<b>Company</b>	Trenz Electronic GmbH
<b>PCN Number</b>	PCN-20210618
<b>Title</b>	TE0823-01 eMMC Change and Product Update
<b>Subject</b>	BOM change
<b>Issue Date</b>	2021-08-04

This change affects all Trenz Electronic TE0823 SoMs of revision 01: TE0823-01

## 2.4 #4 Set S/N to not fitted

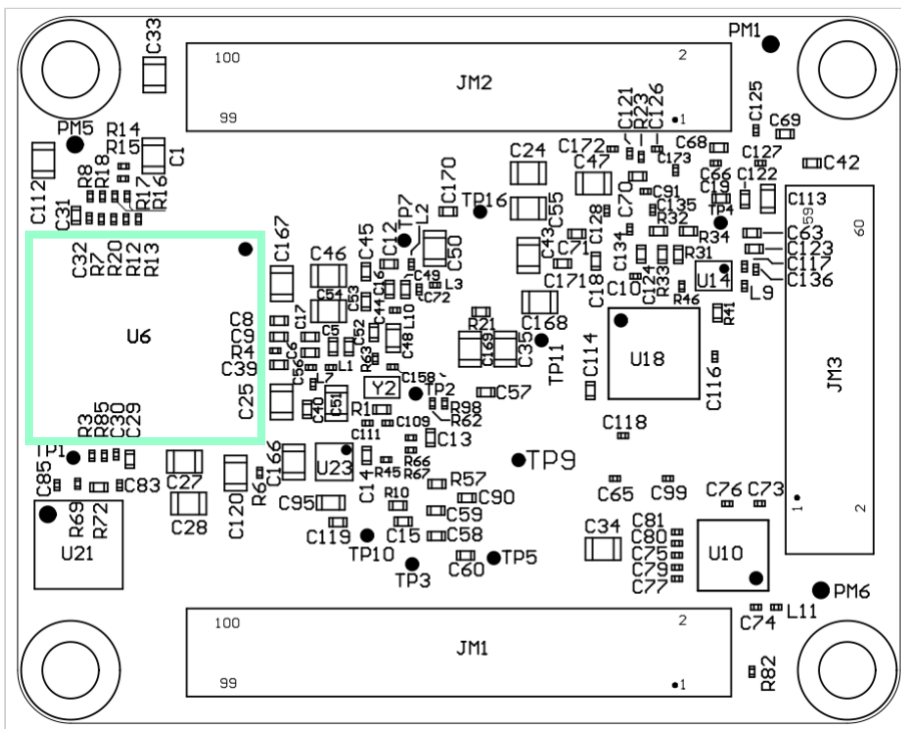
**Type:** BOM change

**Reason:** Part is end of life.

**Impact:** Track it pad no more available.
